Access Compliance Report Public Rights-of-Way (Curb Ramps)

Main Street: NEWPORT_AVE Cross Street: FOOTHILL_BLVD Location: SE

ADA ID: RPAT211018091742 Ramp Type: Type 3 - Combination 1 Initial Pass/Fail: Fail Overall Compliance: No Severity Score: 25

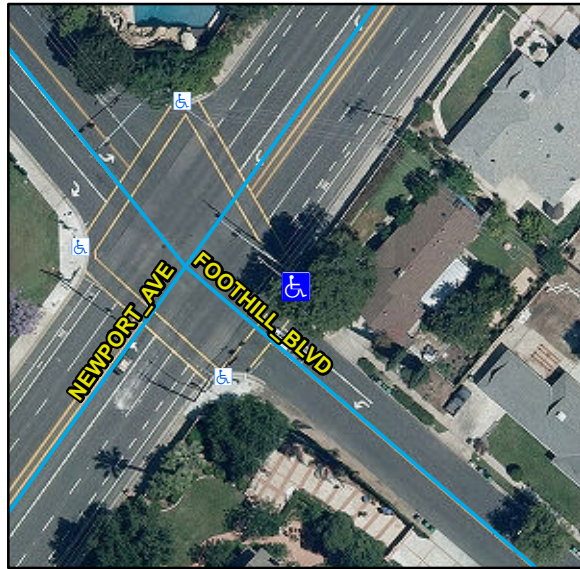
R304.2.2, R304.5.1, R304.5.3, STD 1115

Remove & Replace Curb Ramp With Two New Directional Ramps or Equivalent. Remove & Replace Sidewalk.
